CLARIFICATION

Project:	TISD - Tomball HS Athletic Improvements	Date:	9/22/2026
Project Number:	250515	Clarification No.:	Pre-Bid CLA - 01
To:	DIG Engineers 11 Greenway Plaza, 22nd Floor Houston, TX 77046	Attention:	Danial Wagner Vice President - DIG

DESCRIPTION OF CLARIFICATION

Revised the Technology drawings to clarify Base Bid and Alternate scope requirements, including associated alternate keynotes. Updated Division 27 specifications to incorporate the approved equipment racks provided by Tomball ISD Technology Department.

Item 01 TS-101 – TECHNOLOGY SITE PLAN

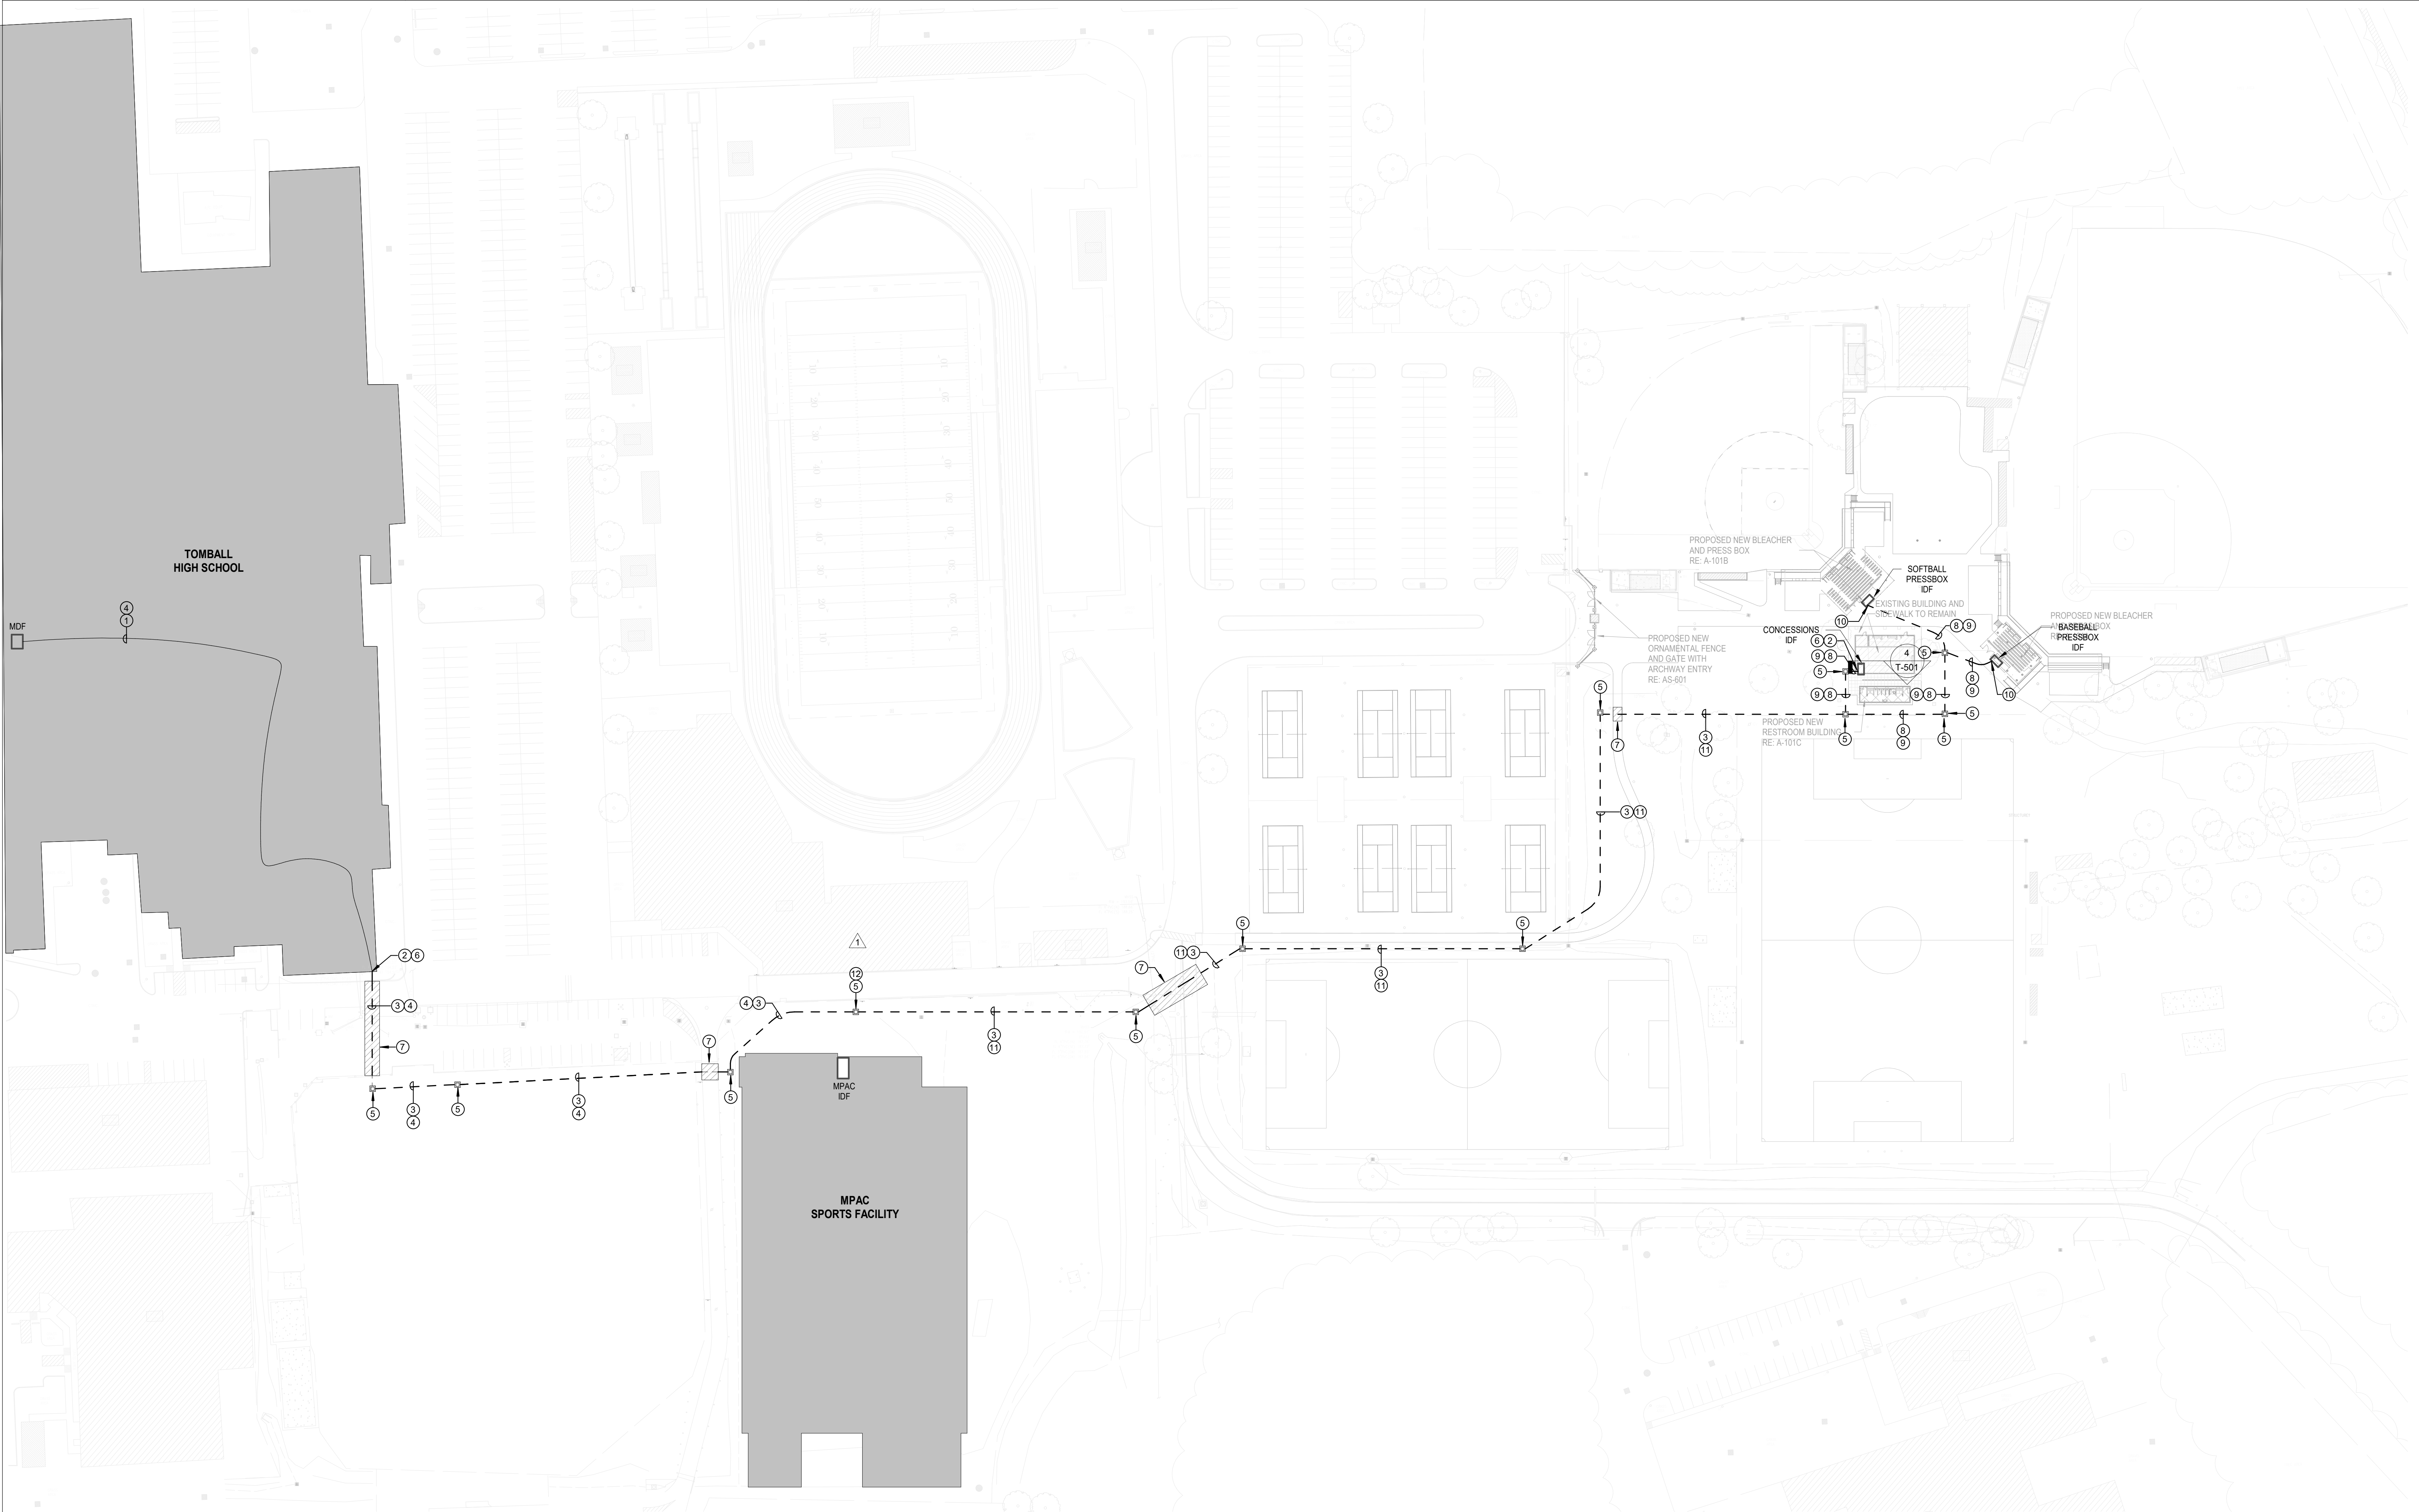
- a. Updated the Technology Site Plan General Notes:
 - i. Note A: (BASE BID) SCOPE OF WORK: THE CONTRACTOR SHALL PROVIDE EMPTY CONDUIT PATHWAYS FOR FUTURE FIBER OPTIC CABLING TO THE BASEBALL AND SOFTBALL PRESS BOXES. REMOVE AND REINSTALL EXISTING SPEAKERS. MAKE SAFE EXISTING SPEAKER AND SCOREBOARD CABLING FOR EXTENSION AND RECONNECTION AT THE NEW PRESS BOXES. FIBER OPTIC CABLING AND TERMINATION EQUIPMENT ARE NOT INCLUDED IN THE BASE BID.
 - ii. Note B: (ALTERNATE 3) SCOPE OF WORK: THE CONTRACTOR SHALL PROVIDE 12-STRAND SINGLE-MODE FIBER OPTIC CABLING, FIBER TERMINATION CABINETS, AND ASSOCIATED TERMINATIONS AT THE BASEBALL AND SOFTBALL PRESS BOXES. PROVIDE THE REQUIRED FIBER OPTIC INFRASTRUCTURE FOR THE MPAC FACILITY AS INDICATED ON THE DRAWINGS.
- b. Changed all 24-strand fiber to 12-strand.
- c. Added *(Alternate 3) to all fiber related scope of work.

TS-102

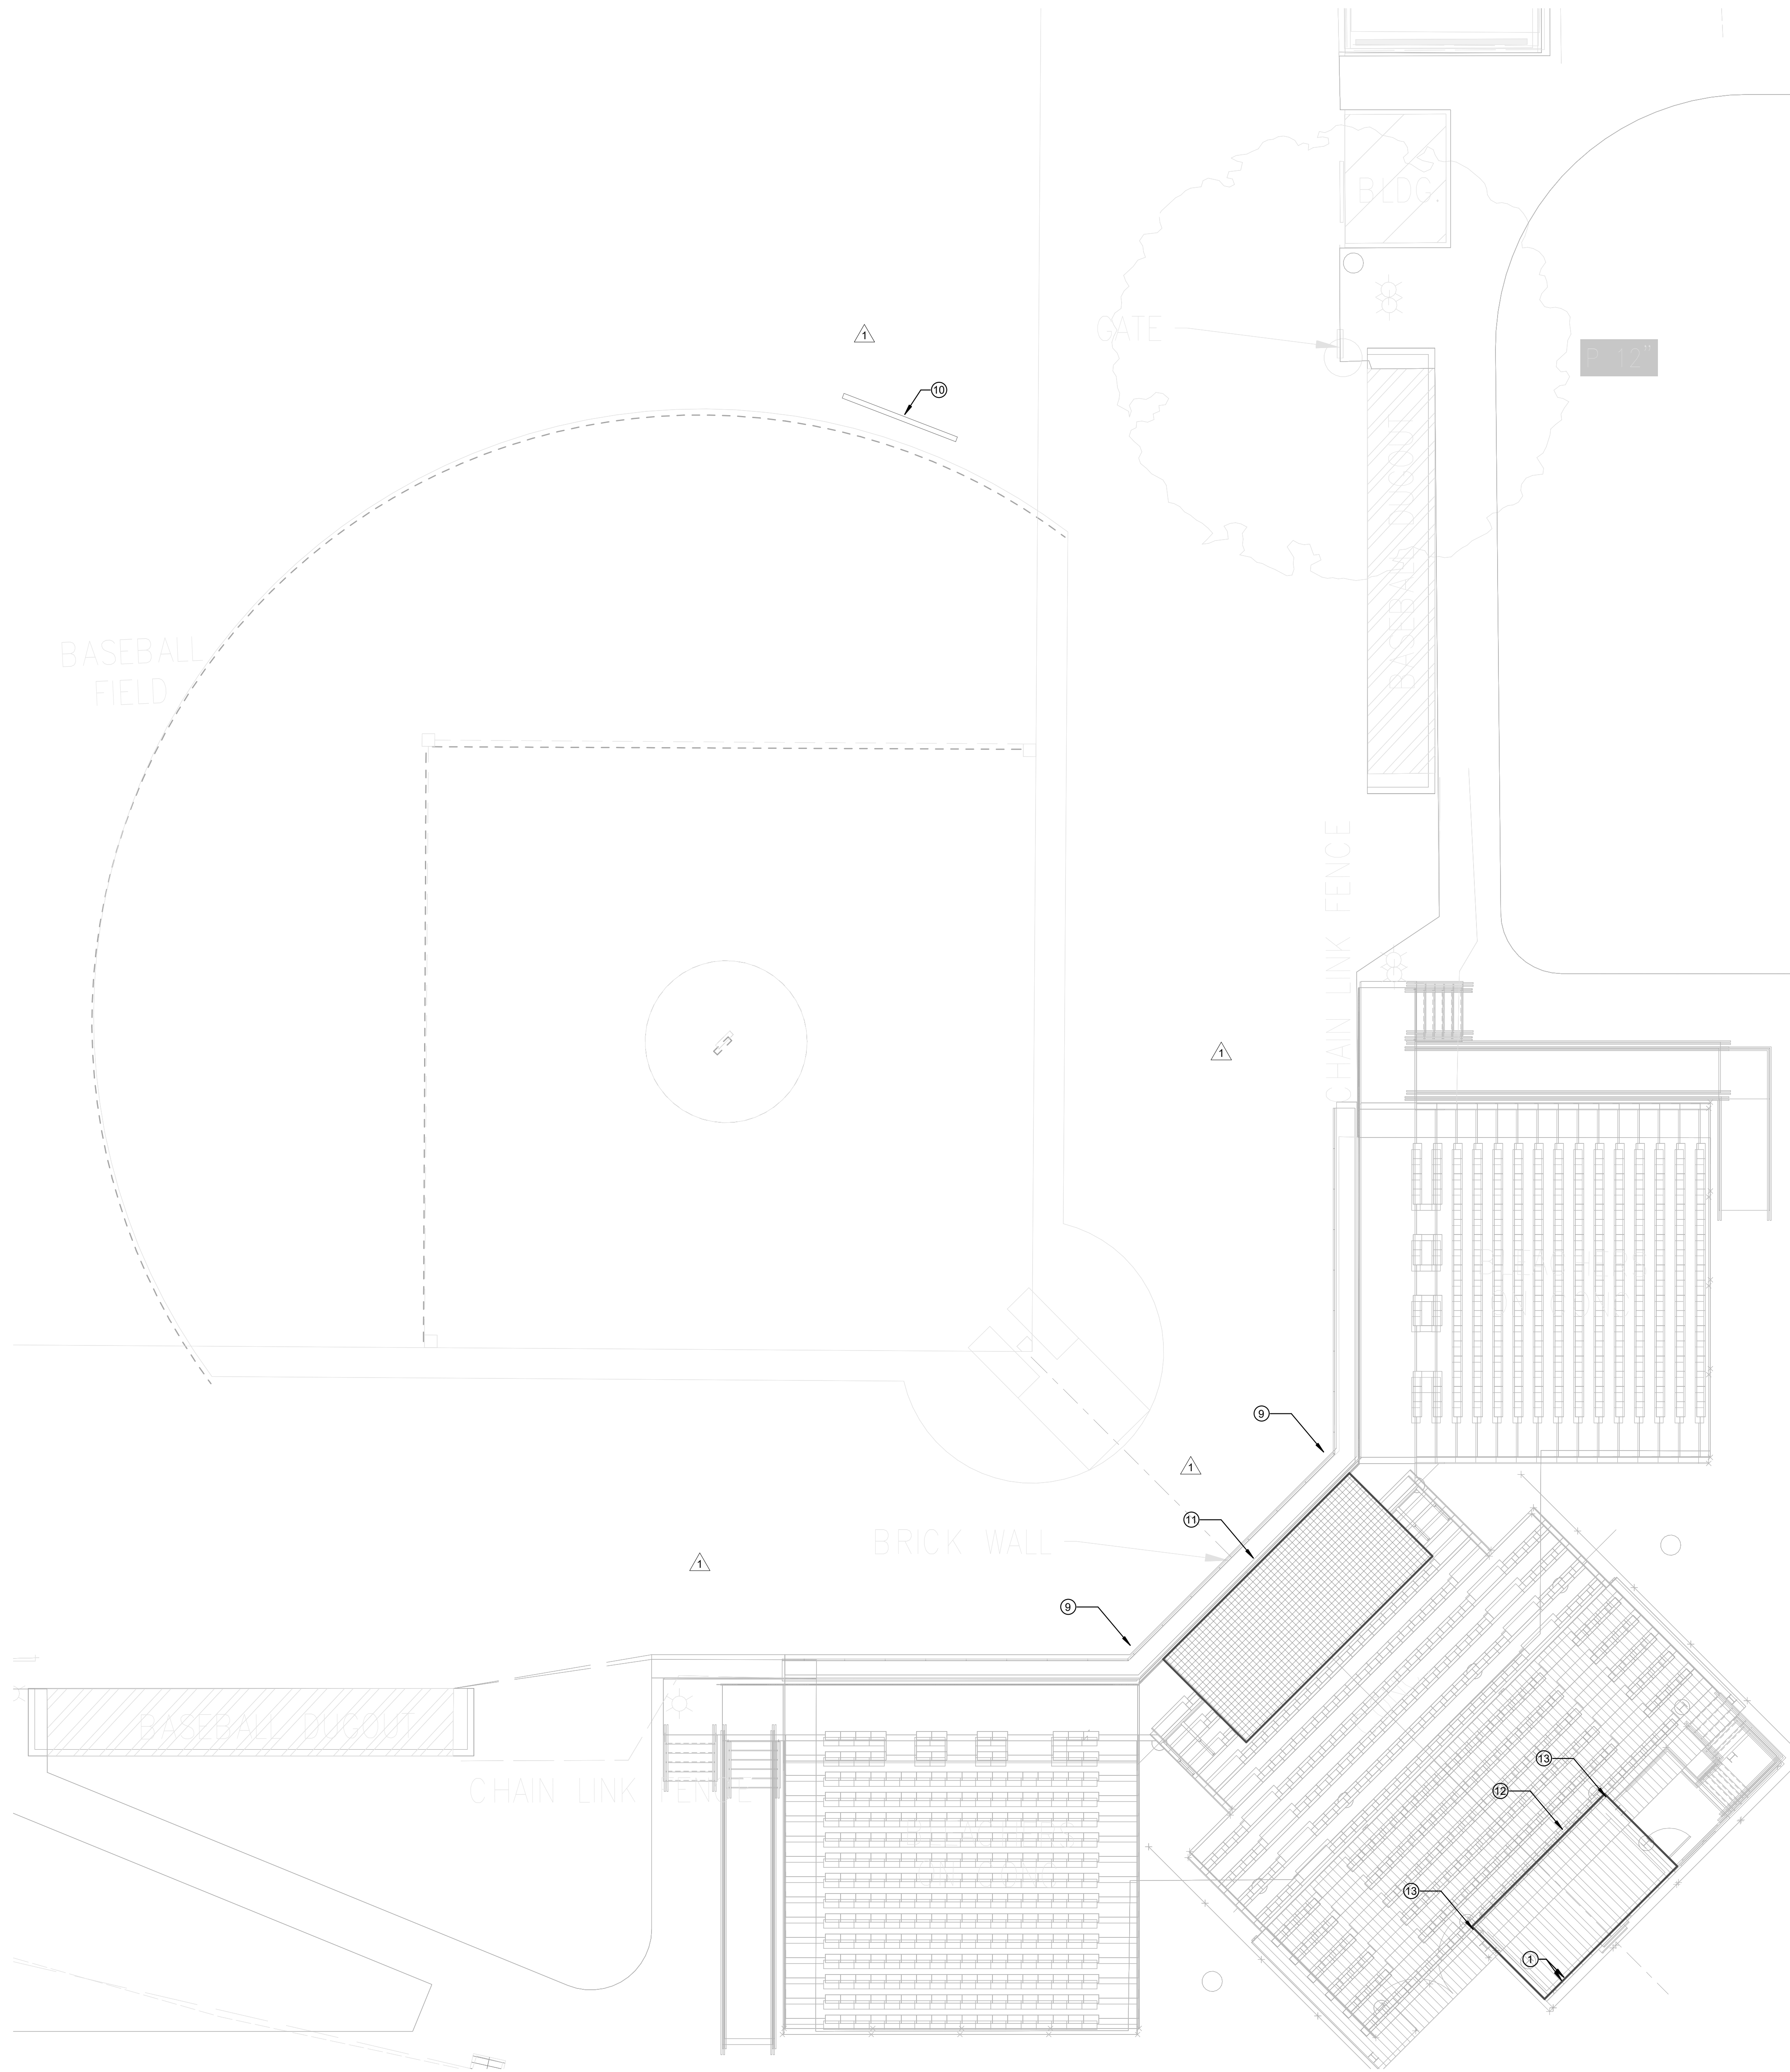
Item 02 TS-102 AND TS-103 TECHNOLOGY KEYED NOTES

- a. Added *(ALTERNATE 3) to keyed note 8.
